Community Solar Project Interconnection  
**Community Solar Project System Impact Study Report**

**(“Applicant”)  
OCS002**

Proposed Point of Interconnection  
**Circuit 5D126 out of Prineville substation near 44°17’4.24”N,  
120°53’18.28”W**

**May 13, 2020**

Figure 2: One Line Diagram

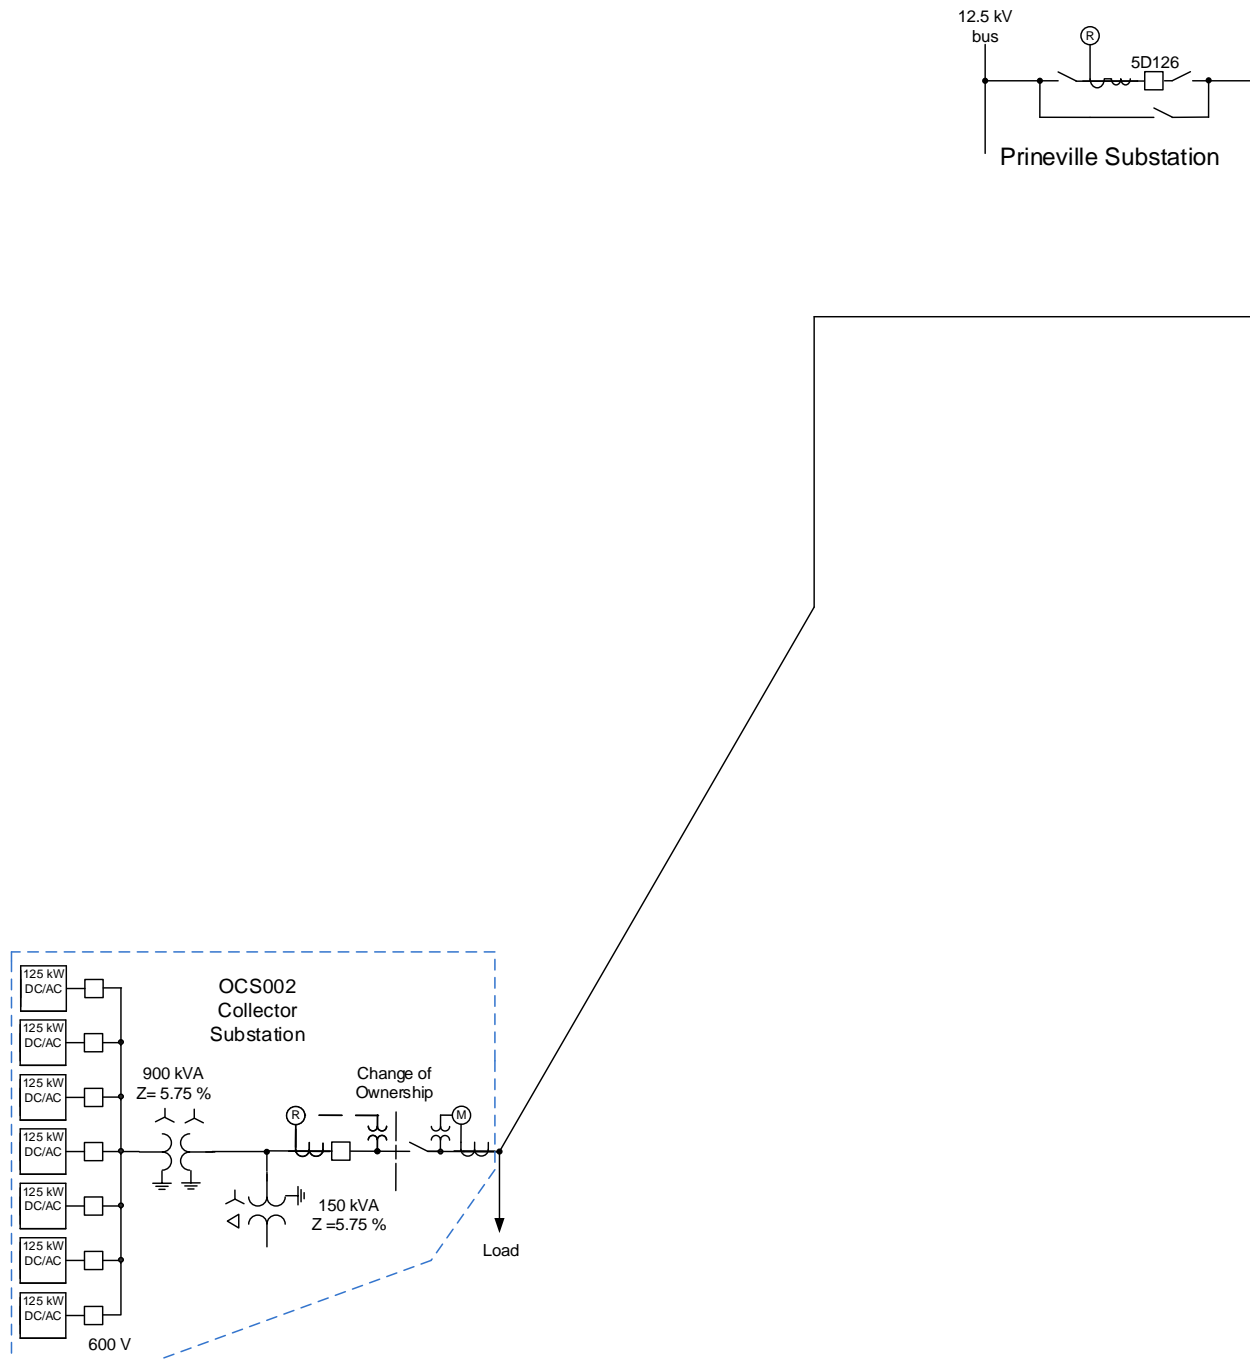
The Applicant will be required to install a transformer that will hold the phase to neutral voltages within limits when the generation facility is isolated with the Public Utility's local system until the generation disconnects. The proposed wye – wye step-up transformer will not accomplish the stabilization of the phase to neutral voltages on the 12.5 kV system. The circuit that the project is connecting to is a four wire multi-grounded circuit with line to neutral connected load. Figure 2 shows the addition of a wye – delta grounding transformer of adequate power size and impedance that will meet the requirement.

The increase in the fault duty on the system as the result of the addition of the generation facility with photovoltaic arrays fed through 7 – 125 kW inverters connected to a 900 kVA 12.5 kV – 600 V transformer with 5.75% impedance will not push the fault duty above the interrupting rating of any of the existing fault interrupting equipment.

A 12.5 kV circuit recloser will need to be installed at the Applicant's generating facility. The circuit recloser will need to be equipped with a Schweitzer Engineering Laboratories (SEL) 651R relay/controller and voltage instrument transformers mounted on the utility side of the circuit recloser. The 651R will perform the following protection functions:
